TUMBI UMBI RETIREMENT LIVING PROJECT

**RESPONSE TO SUBMISSIONS AND
AMENDMENT REPORT- SSD-63475709**

Mingara Recreation Club, 14 Mingara Drive,
Tumbi Umbi

24 July 2025

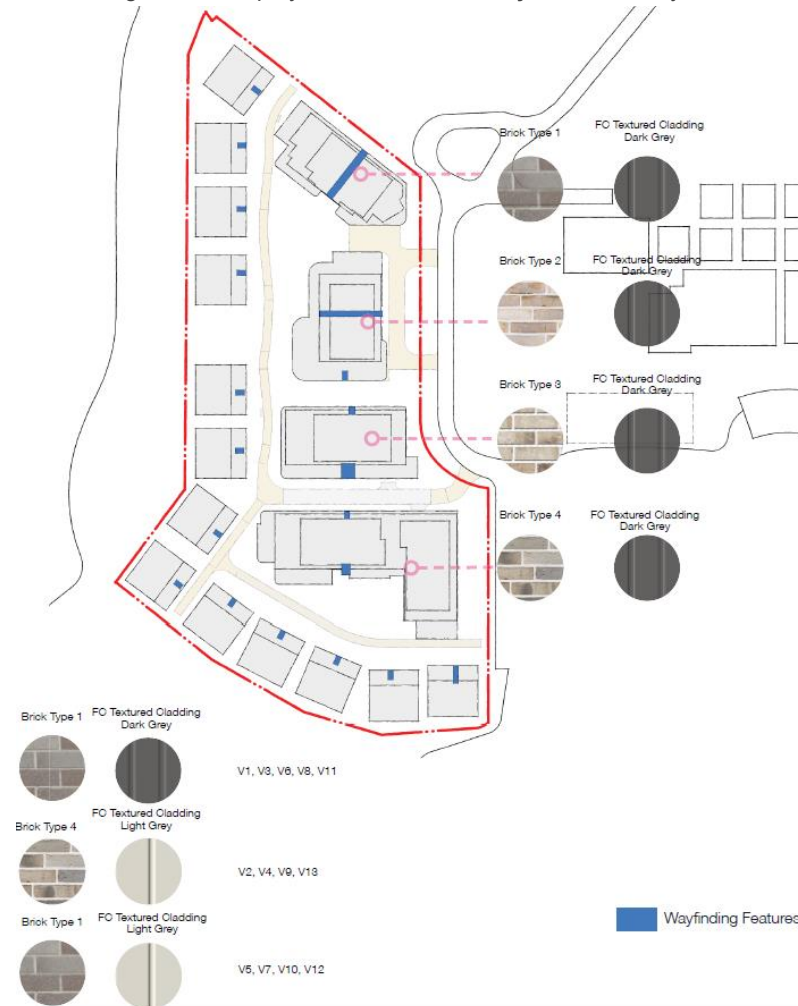
The facades on upper levels of the parts of the building containing the aged care beds could be better resolved. There is a lack of connection with the ground level podium. The grey walls are punctuated by windows but little else has been done to provide an aesthetically pleasing design.

The architectural intent for the HCS within Building 2 has been designed to ensure visual and functional integration with the surrounding ILUs, rather than treating the aged care component as a standalone or institutional element. This approach fosters a cohesive residential environment and supports a sense of community, avoiding the visual and social segregation often associated with aged care facilities.

The façade of Building 2 has been deliberately designed to mirror the pattern of brick and glazing grids established in Buildings 1, 3, and 4, thereby maintaining consistency across the development. This articulation helps tie the upper levels to the overall architectural language and reinforces the building's residential character. In response to design feedback, the façade treatment and material palette have been revised to improve the visual connection between the upper levels and the ground-level podium. These updates, illustrated in the amended elevations, reduce the prominence of grey wall surfaces by incorporating warmer tones and varied materials, enhancing visual interest and softening the overall appearance.

Figure 4 Originally Proposed Athletics Interface

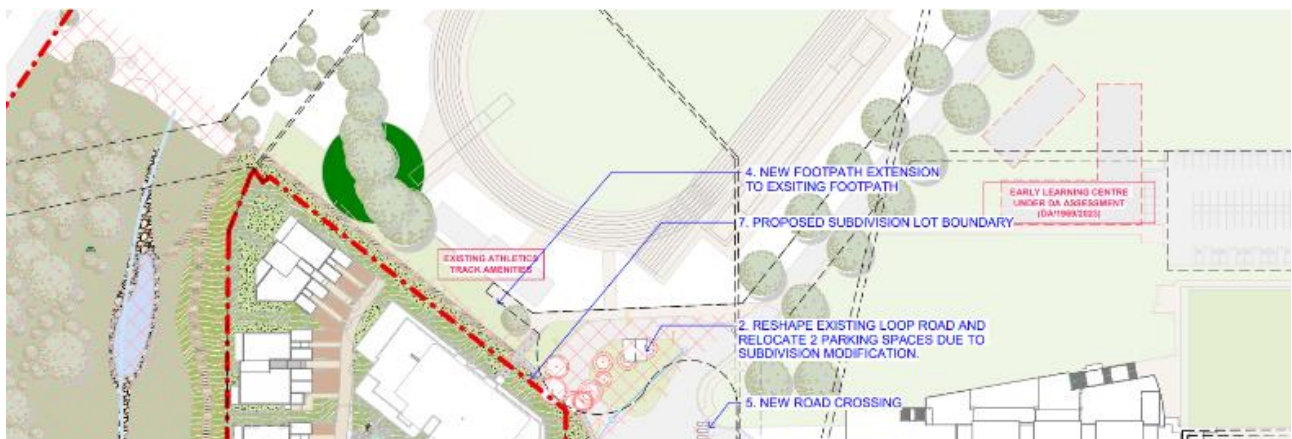
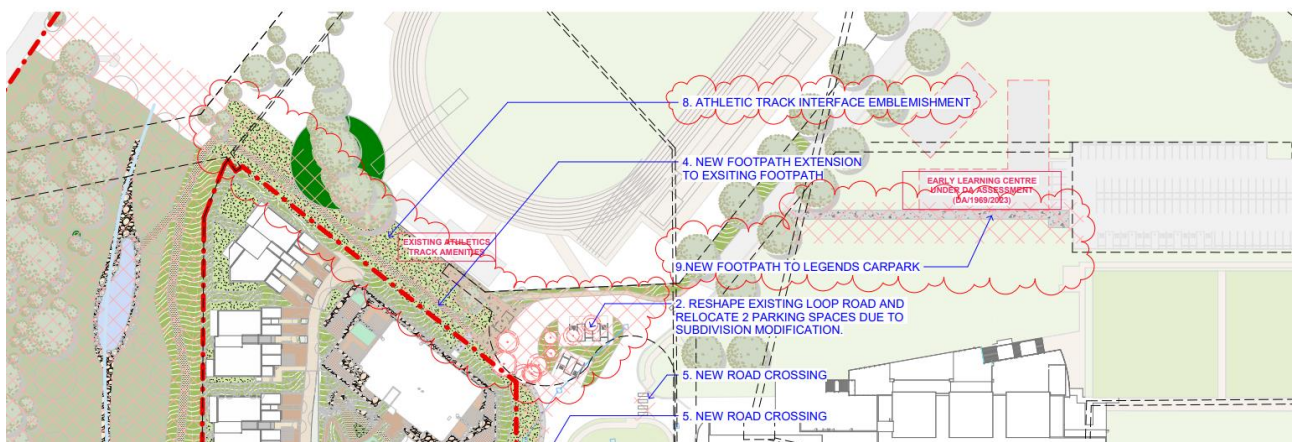
Comment	Response
The Department notes that the proposal seeks to modify the existing loop road at the entrance to the athletics track, however the proposal would remove the informal hardstand/drop off area. The Department considers an opportunity exists to improve the relationship with the proposal and to provide a formal entry plaza to the athletics track. Accordingly, the Department requests: (a) the submission of revised plans detailing an urban design response at the athletics track entry that provide a positive interface between the athletics track and the proposed development (b) vehicle swept path details for the largest vehicle demonstrating the proposed augmentations to the drop off loop road will satisfactorily accommodate the desired vehicles.	the many concerns raised in the submissions including safety and accessibility. The location of the all weather and over flow car parking areas will be managed, signed and include formed and lit pedestrian paths and use of traffic controllers. The proposed overflow location is also located in a more visually prominent area of the site than the current grassed area, as it fronts Wyong Road and the internal driveway road as well as being over looked by the Club building as well as the future ELC, improving the safety. The proposed development has been amended to accommodate an updated interface between the seniors housing development and the entrance to the athletics track. This includes the following: ▪ Provision of a pathway between the athletics track and retirement village to provide access to riparian area and waterway. ▪ General site landscaping including trees, shrubbery and grassed areas, ▪ Provision of a new hardstand and paved areas to connect with the existing concrete path and improve the arrival experience for athletics track users. ▪ Removal of existing light pole, and planting of a new garden bed. ▪ Provision of five (5) accessible car parking bays. ▪ Incorporation of bus drop off/ pick area In addition to the above, vehicle swept paths have been prepared by Traffix (traffic engineer) at Appendix F which confirm that the vehicles which presently use the loop road can continue to use this space following augmentation. Previously, the absence of a formal hardstand to accommodate the large number of people attending events led to significant deterioration of the grassed areas. The proposed design responds to this issue by incorporating dedicated seating areas, providing a more comfortable and functional space for waiting spectators and improving the overall amenity of the interface, accommodate waiting spectators or staff, enhancing comfort and usability while supporting a more welcoming interface.

The amended project includes works beyond the development site boundary (indicated in red dashed line in Figures below) to embellish the interface between the seniors housing and the athletics track, improve the main entrance and forecourt to the track, implement safety measures and accessible parking and provision of an accessible pedestrian pathway to connect to conveniently located car parking. The embellishments also improve the pedestrian path, network, connectivity and experience around the site.
